REQUEST FOR INFORMATION

PROJECT: UOG IFB-23-01	RFI NO.	1
------------------------	---------	---

Subject: **RFI for the list of Item** Date: **June 29, 2023**

School of Health - Nursing Annex
EDA Project No. 0779-07657 UOG Scientific Education and Research Facilities
Mangilao, Guam
OWNER: UNIVERSITY OF GUAM
SHEET TITLE: **SITE ELECTRICAL PLAN SECTION A & B - NURSING BUILDING ANNEX**

1 SECOND FLOOR POWER PLAN
2EP102 1/8" = 1'-0"

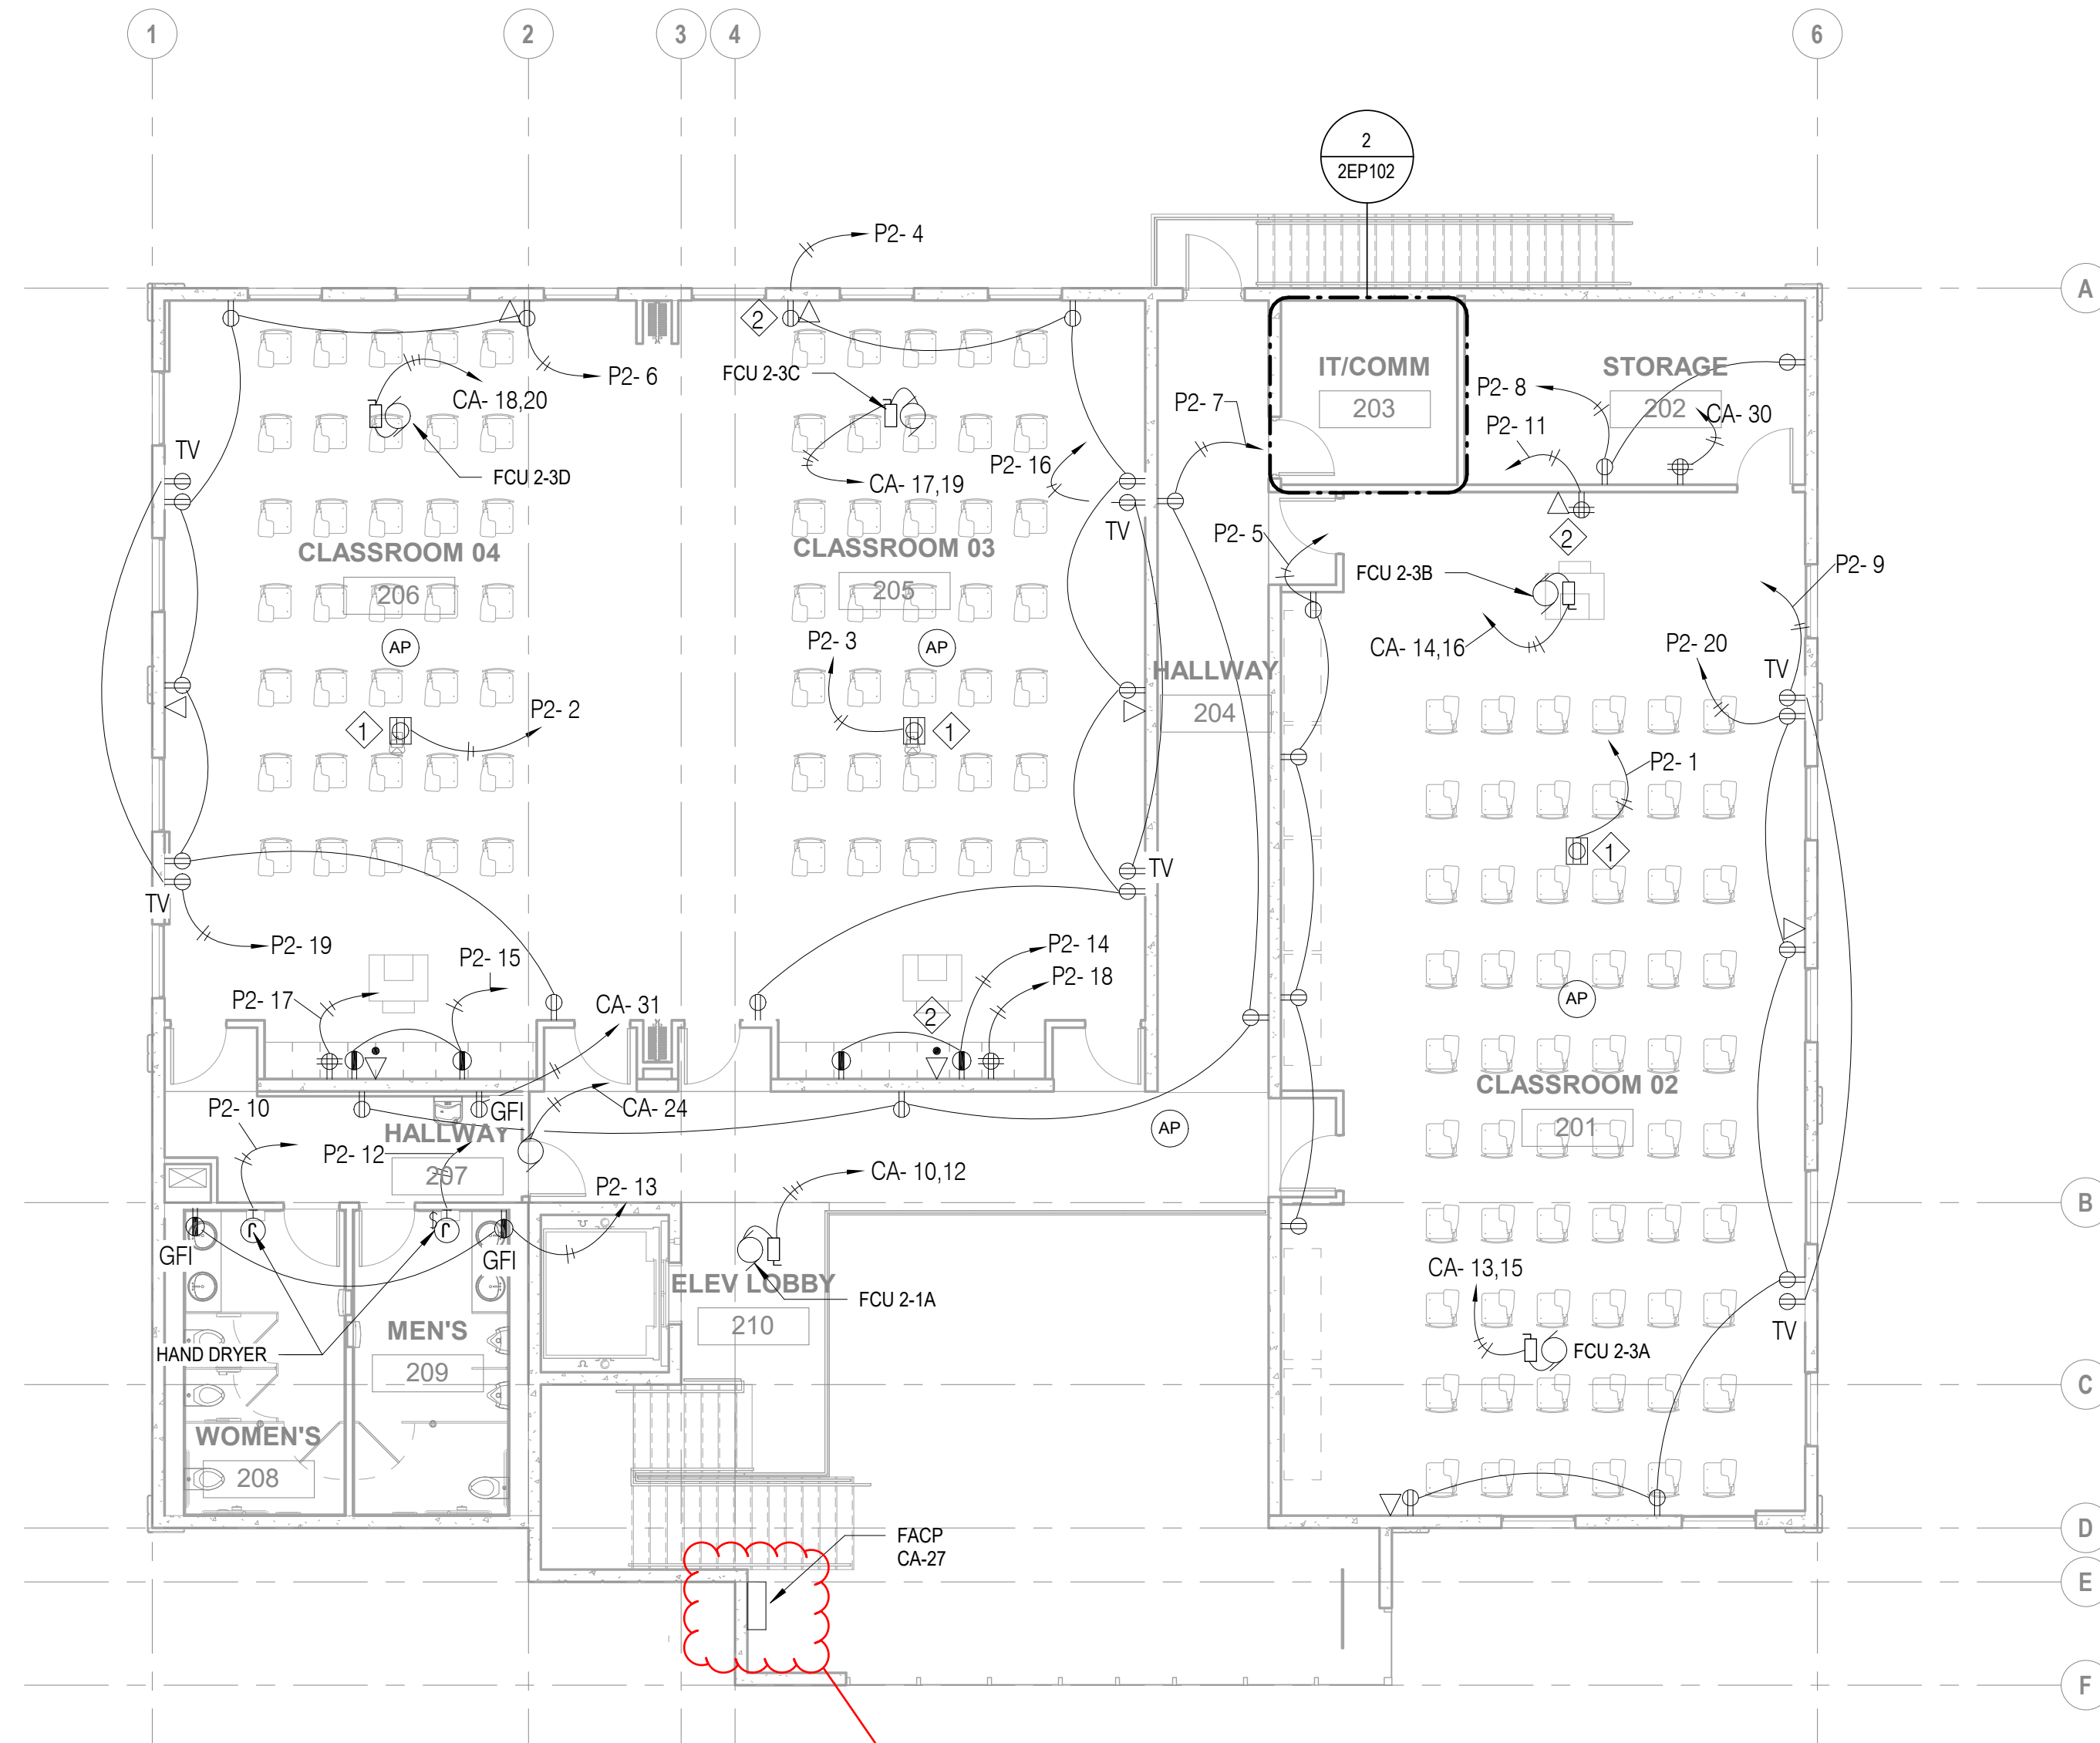
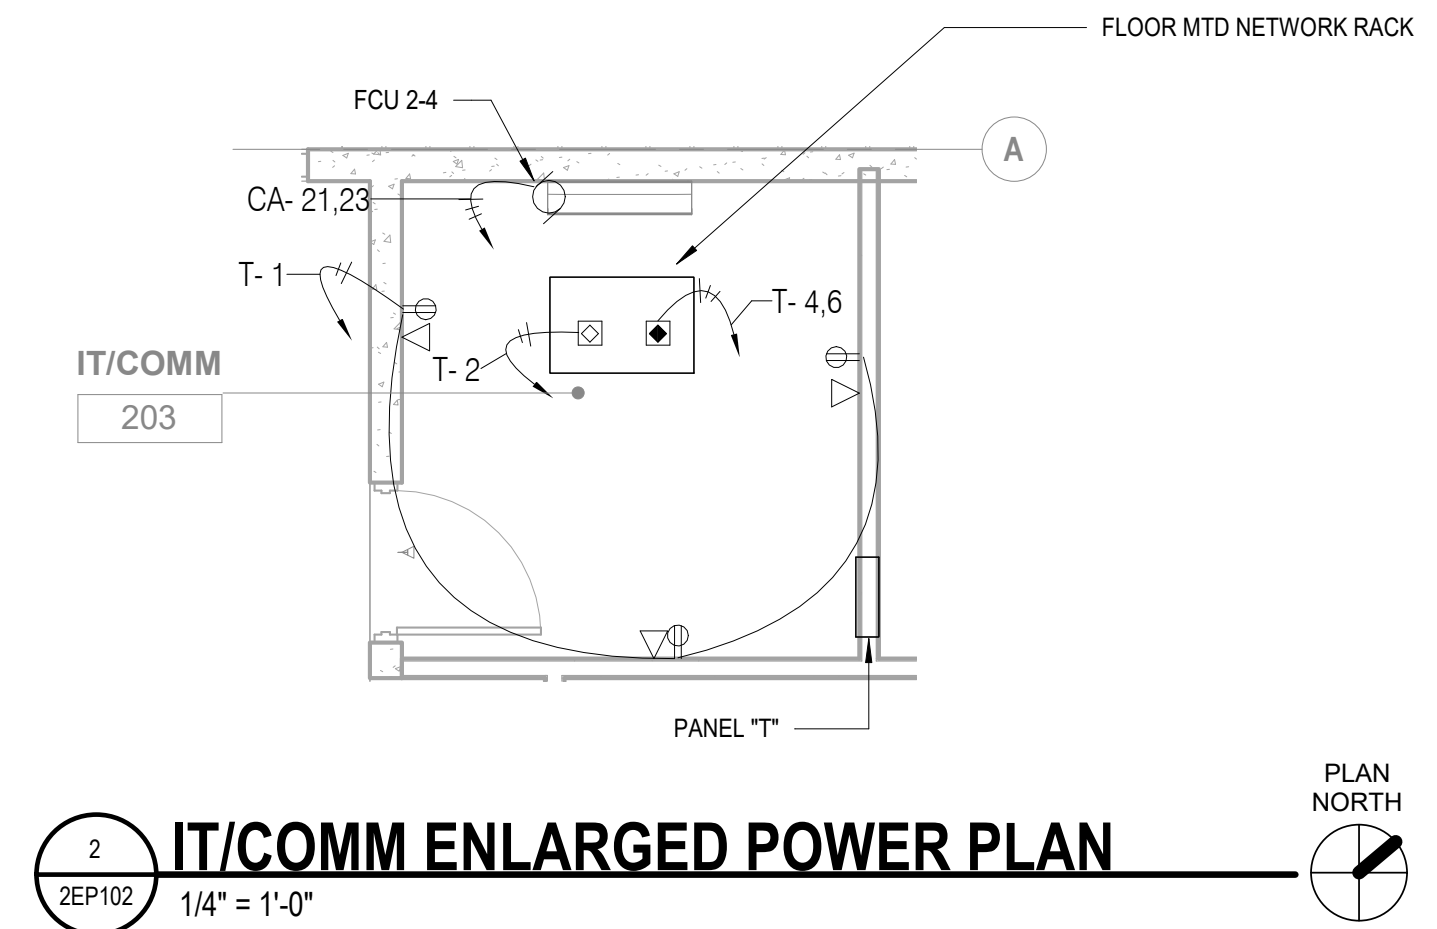
Please confirm if this will be provided by GC. Kindly provide the dimension / specifications if not.
*FACP is part of the bid package, see specifications

1 ONE-LINE DIAGRAM

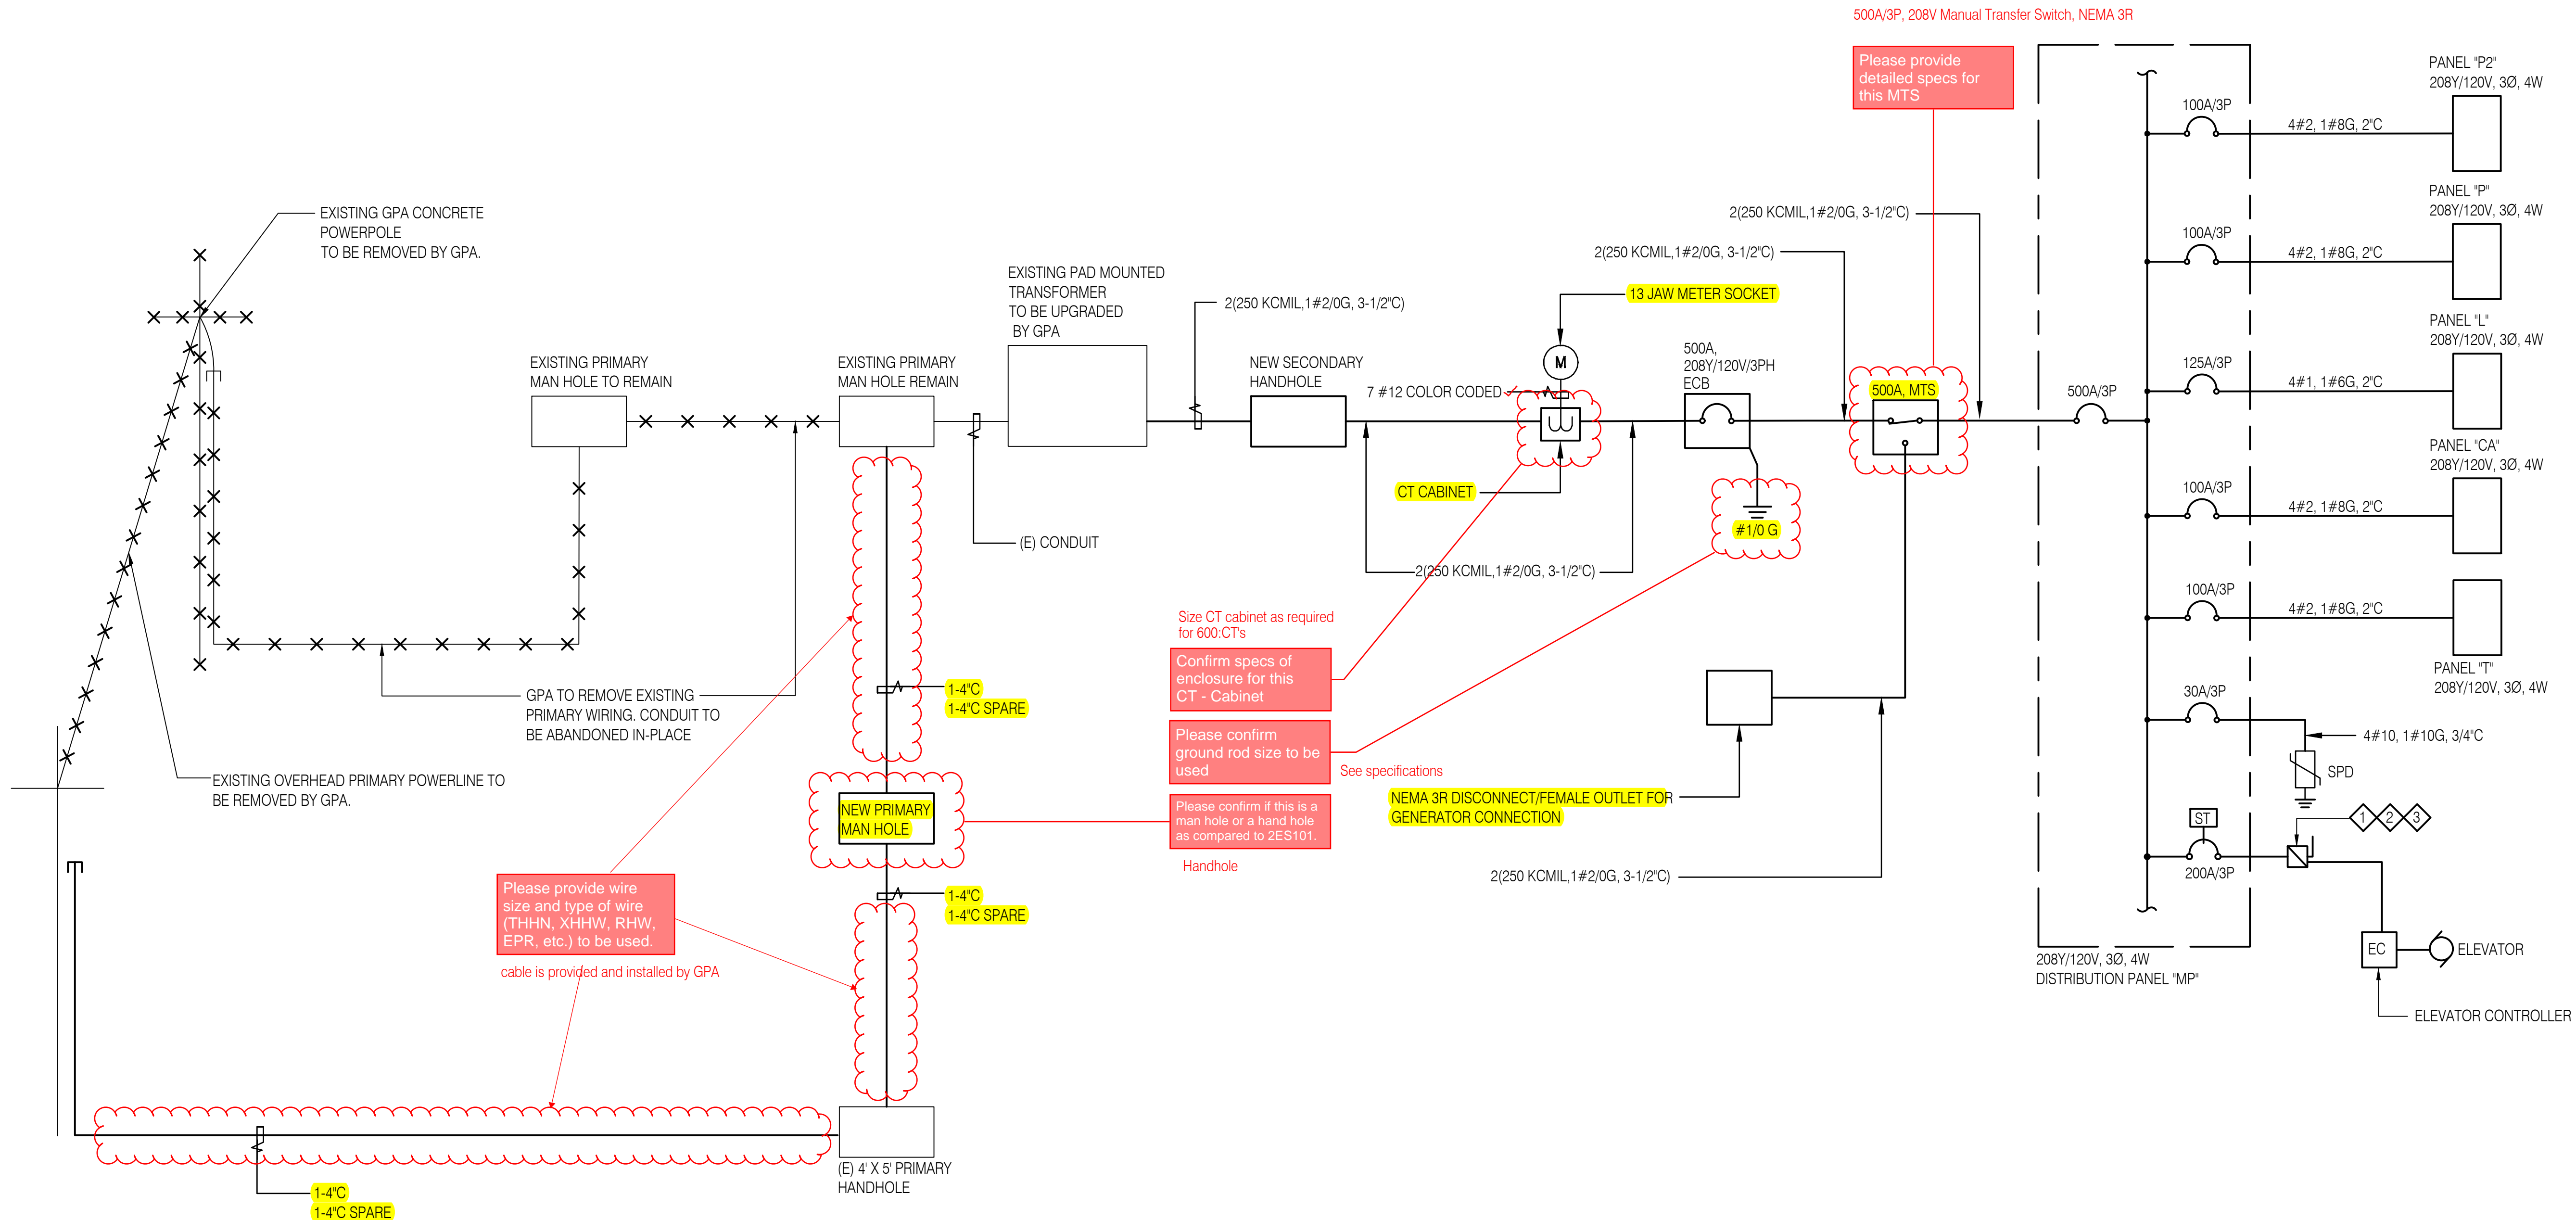
Please provide wire size and type of wire (THHN, XHHW, RHW, EPR, etc.) to be used. cable is provided and installed by GPA

Confirm specs of enclosure for this CT - Cabinet

Please confirm ground rod size to be used

Please confirm if this is a man hole or a hand hole as compared to 2ES101.

Please provide detailed specs for this MTS

Size CT cabinet as required for 600:CTs

Handhole

See specifications

4 POLE RISER DETAIL
E501 NTS

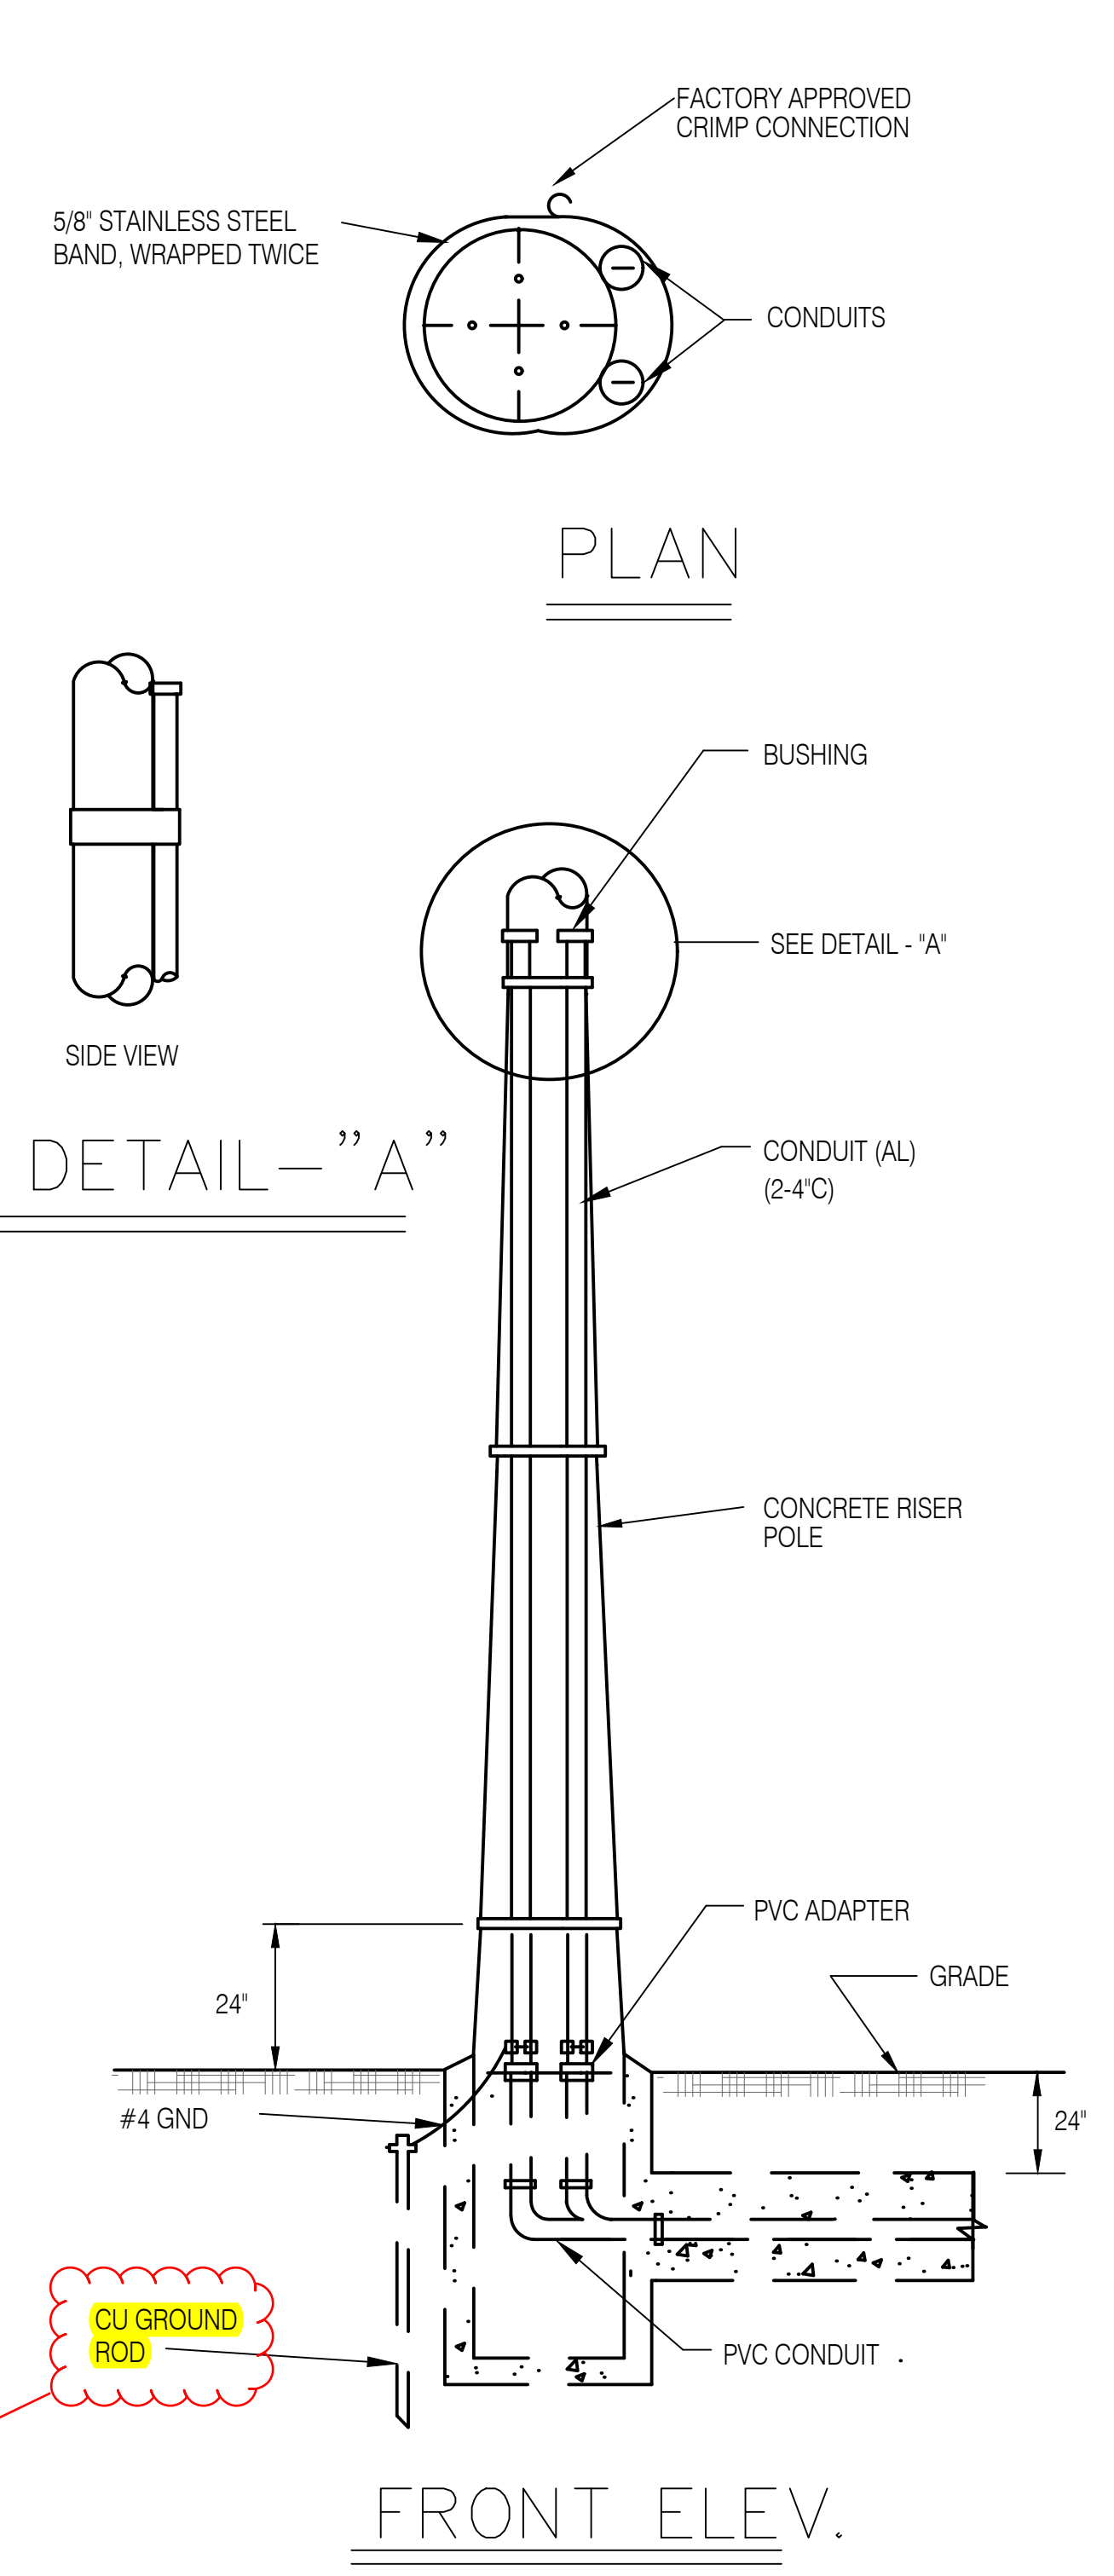
Please confirm ground rod size
See specifications
